MEMORANDUM

TO: District of Columbia Zoning Commission
FROM: ^{JLS} Jennifer Steingasser, Deputy Director
 Historic Preservation and Development Review
DATE: June 7, 2019
SUBJECT: ZC 15-27A – Final Report for a Second Stage Planned Unit Development (PUD) and Modification of the First Stage PUD for Building A2 at 300 Morse Street, N.E. in Florida Avenue Market

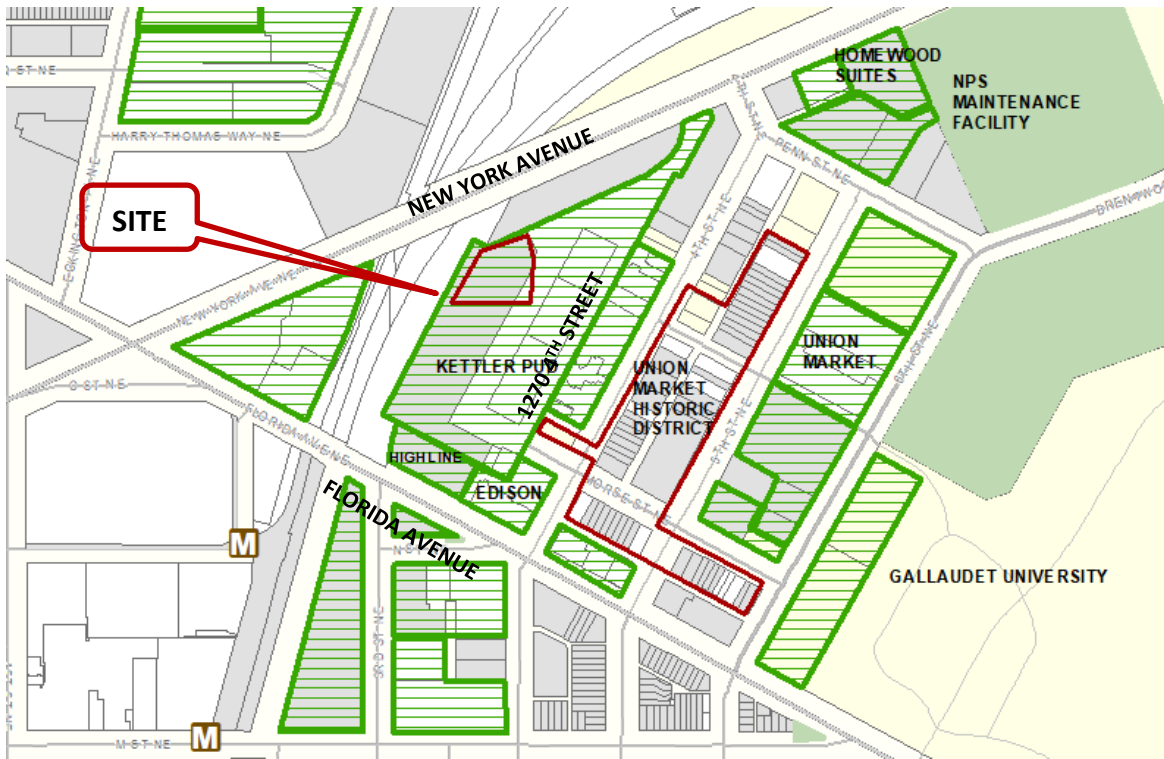
<p><u>Neal Place Park Children’s’ Play Spaces</u> Given the shortage of green space in Florida Avenue Market, there is a need to optimize all park space for recreation. As such, a children’s play space should be incorporated; the proposed boulder sculpture presents an opportunity to provide an interactive climbing structure. The center of the park should be functional for recreation and not just a stormwater swale.</p>	<p>The design for Neal Place Park intentionally contrasts with and compliments the public space programming within the overall PUD site... Morse Street Plaza includes features such as terraced seating, benches and cafes, and a “Gantry” structure with a fog feature and surrounding communal seating that will animate the plaza and encourage interaction.</p> <p>The design of Neal Place Park is intended to provide smaller gathering spaces immersed in natural elements to offer a unique experience when</p>	<p>OP continues to suggest modifications to the park intended to increase its functionality, such as ensuring that the boulder sculpture is something that is interactive and can be climbed. If possible, some of the space devoted to stormwater should be flat, green space to allow more functionality.</p>

<p>compared to the Morse Street Plaza. Although smaller in size, Neal Place Park also includes a variety of elements to engage the public, such as natural boulders of different shapes and sizes; café, garden, and sidewalk seating; interesting paving patterns; a bridge inspired by the nearby Great Falls Trail; canopy trees; and a variety of garden areas. Neal Place Park is bounded by ambient lighting on Building A2 as well as feature lighting located at various points within the park to light the park and ensure that it feels like a safe and welcoming environment.</p> <p>...the Applicant has minimized to the greatest extent possible the areas devoted to stormwater management and bioretention within Neal Place Park. The bioretention areas that are proposed are critical to meeting the overall stormwater management requirements for Building A2...</p>	
<p><u>Water Feature</u> A water feature should be provided in Neal Place Park.</p>	<p>A water feature has not been included in the proposed design, as the design has significantly improved and advanced since the first stage PUD was approved. The plaza and seating in the first stage PUD lacked a unifying concept and needed a central focal point such as a water feature to carry the design. However, the new concept is grounded in regional geographies and designed as a lush, natural, and intimate environment that attracts the public through dynamic pavement design, immersive planting, and welcoming seating areas that spill over the Building A2 property line and into the public space.</p> <p>The design for Neal Place Park intentionally contrasts with and compliments the public space programming within the overall PUD site... The design of Neal Place Park is intended to provide smaller gathering</p>	<p>The applicant has demonstrated that a water feature would challenge the stormwater management system. In response, OP has suggested modifications to the park to ensure that it would be more functional, such as ensuring that the boulder sculpture is something that is interactive and can be climbed. If possible, some of the space devoted to stormwater should be flat, green space to allow more functionality.</p>

<p>spaces immersed in natural elements to offer a unique experience when compared to the Morse Street Plaza.</p> <p>The stormwater management system for Building A2 also prevents the applicant from incorporating a water feature into Neal Place Park. Building A2 includes extensive stormwater management elements at the penthouse level, 3rd floor, and ground floor at Neal Place Park. Because the stormwater retention treats gray water captured from the building and the hardscape areas in Neal Place Park, the system is incompatible with a clean-water fountain system that would be needed for a water features.</p>	
<p>Green Spaces A comprehensive site plan showing the location of all green space locations for the PUD should be provided. The plan should include active and passive recreation space as well as connections between them.</p>	<p>Sheet L1.05 of the approved consolidated and first-stage PUD plans showing the landscape plan elements for Morse Street Plaza located at the intersection of Buildings A1, B, and C1 has been provided at Exhibit 21B.</p> <p>A plan showing the green space locations within the overall PUD site will be provided prior to or at the public hearing.</p>	<p>The plan does not show all of the green spaces proposed in the First and Second Stage PUDs. A cohesive plan demonstrating the geographical relationship between parks and green spaces and illustrating their intended purposes should be provided prior to the public hearing.</p>
